DOCKET 50-255 - LICENSE DPR-20 -  
PALISADES PLANT - SEP TOPIC III-3.C,  
INSERVICE INSPECTION OF  
WATER CONTROL STRUCTURES

By letter dated February 22, 1982, the NRC issued an SER for SEP Topic III-3.C for the Palisades Plant. This SER was based on a topic evaluation (SAR) developed and previously submitted by CP Co letter dated December 21, 1981.

Palisades Plant Intake Crib Structure

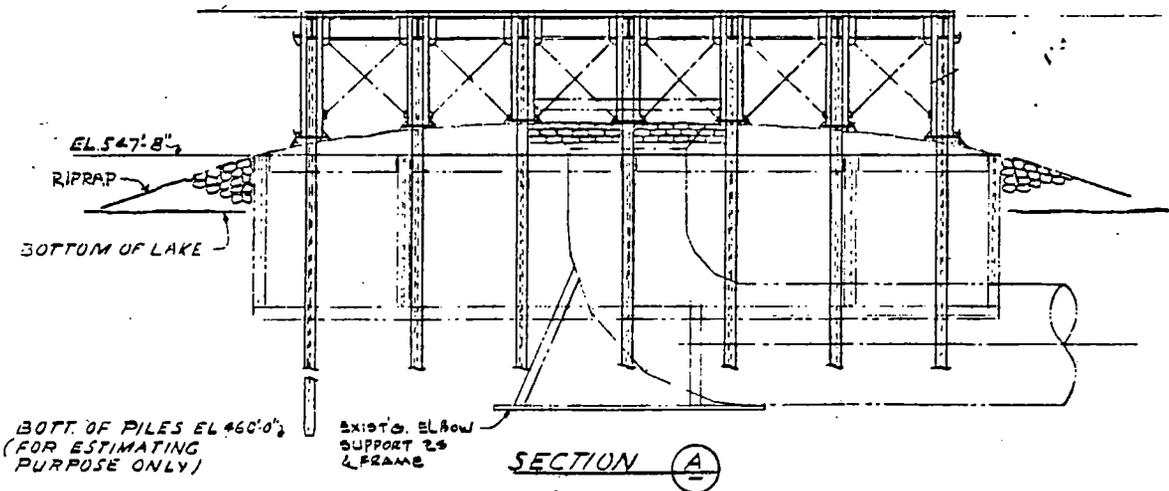
It must be pointed out that the intake crib is a protective structure which does not have a function related to conveying water through the intake pipe. The crib structure and the attached bar racks merely surround the flared end (bell) of the intake pipe to filter out large objects to prevent intake pipe blockage. The crib is a square structure with overall dimensions of approximately 57' x 57', the top of which is approximately 9' above the open end of the bell. The bell dimension at this open end is approximately 18' x 18'. The attached sketch shows the general configuration of the pipe, bell and crib.
